## REMARKS

Version with markings to show changes made to the claims

FIG 1

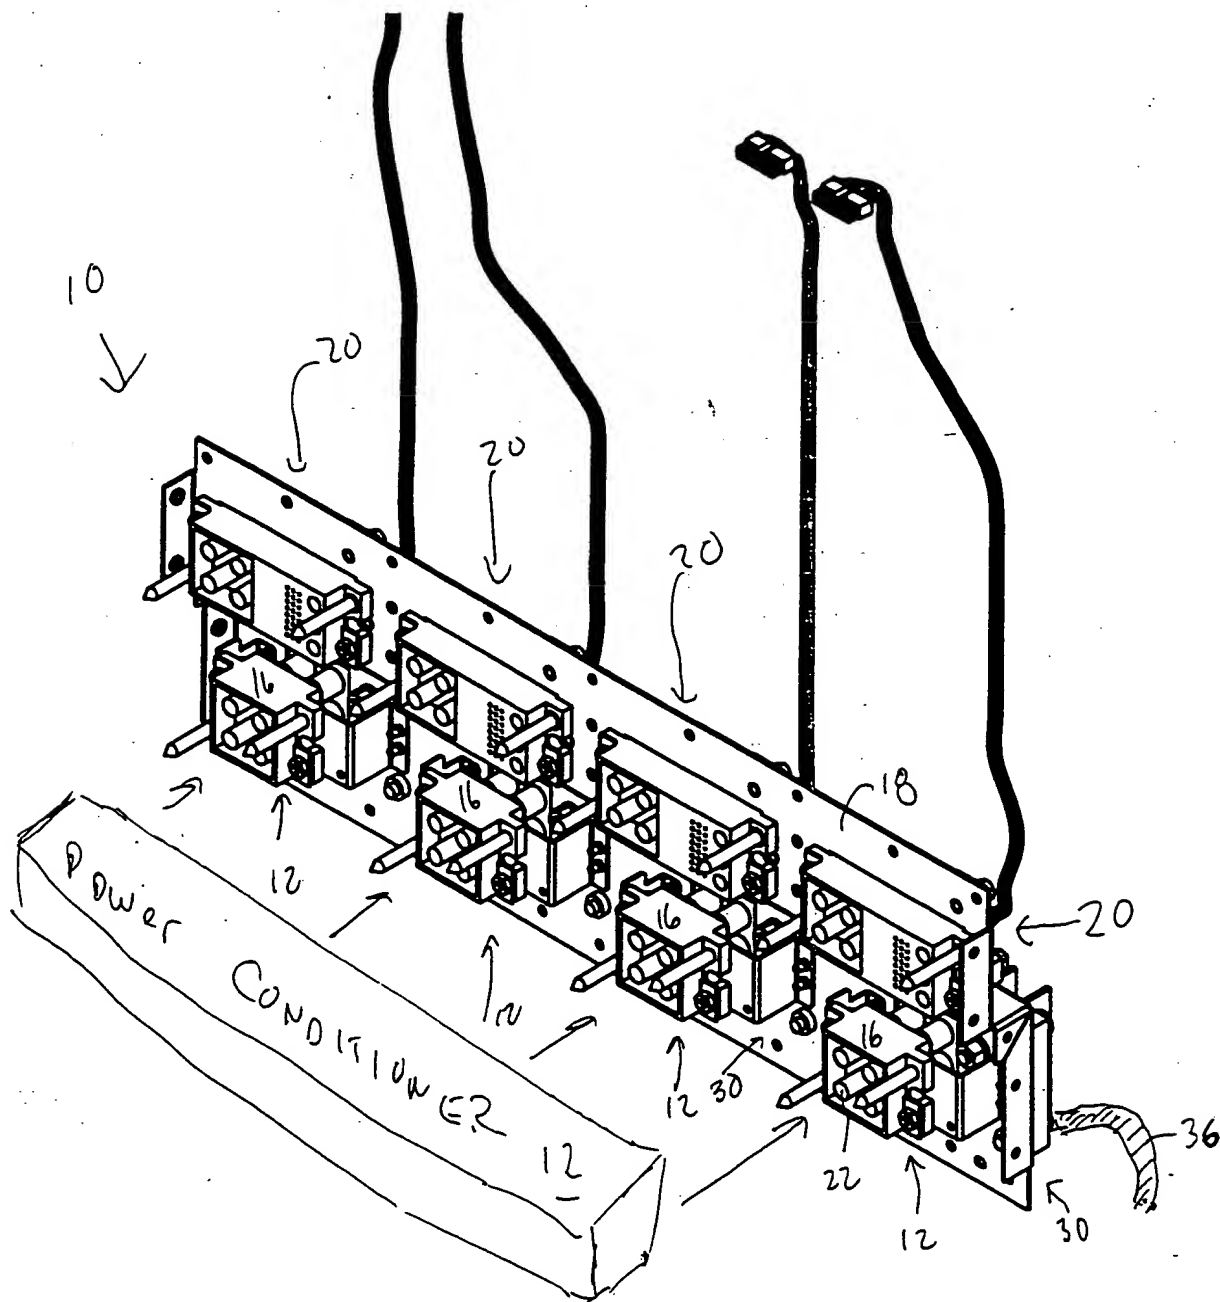
The Examiner has objected to the drawings because the power wire in Claim 7 is not shown in the figures. Respectfully, figure 1 shows the power wire 36. It appears that the "6" of "36" was cut off in copying the figure. An amended figure, with the amendment shown in red, is included. Formal drawings will be provided when the application is allowed.

The Examiner has objected to the drawings because it is unclear to the Examiner exactly what element the lead lines and arrows are pointing to. The figures have been amended, with amendments shown in red, to obviate this objection. Formal drawings will be provided when the application is allowed.
